DESCRIPTIVE REPORT

Registry No. H-10979

General Locality SHELIKOF STRAIT

Sublocality SOUTH OF CAPE KEKURNOI

Figure 2. H10979 Junction Surveys.

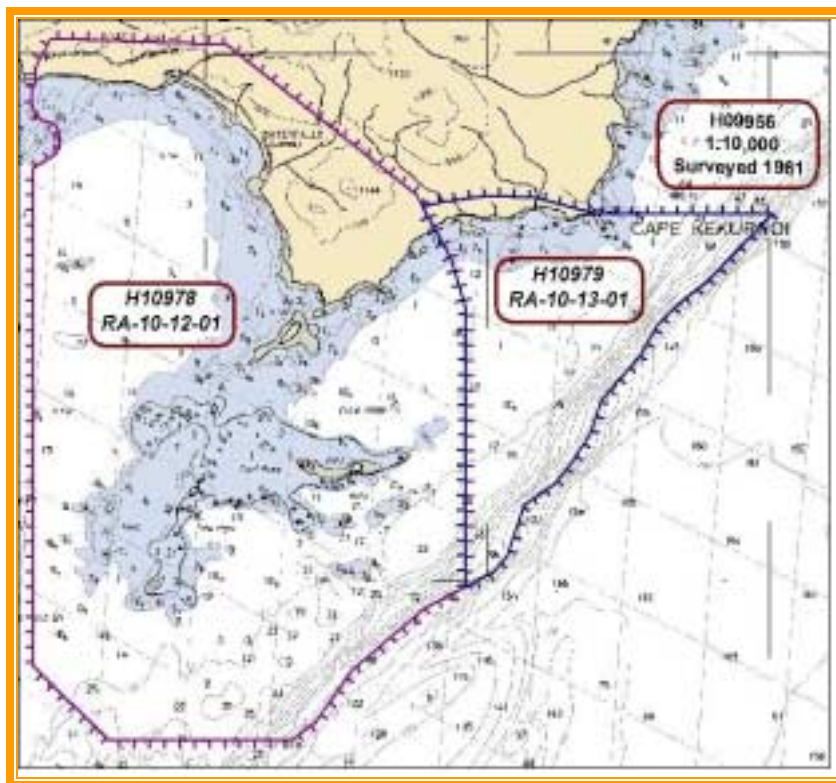
Comparisons with both H10978 and H9956 compare well, with differences generally less than two fathoms.⁵

⁵ PHB revision - The junction with H9956 was not formally completed since this survey was processed previously. A comparison of soundings between the surveys shows close agreement, within two fathoms. Some soundings and features from H9956 been transferred within the common area to better delineate the bottom configuration and to support depth curves common to both surveys.

The junction with survey H-10978 is complete and a "Joins" note has been added to the smooth sheet where applicable. The junction note layer, level 19, is not visible when plotting. Agreement is good between the junctional surveys, within one to two fathoms. One sounding from H10979 has been transferred within the common area to better delineate the bottom configuration and to support depth curves common to both surveys.
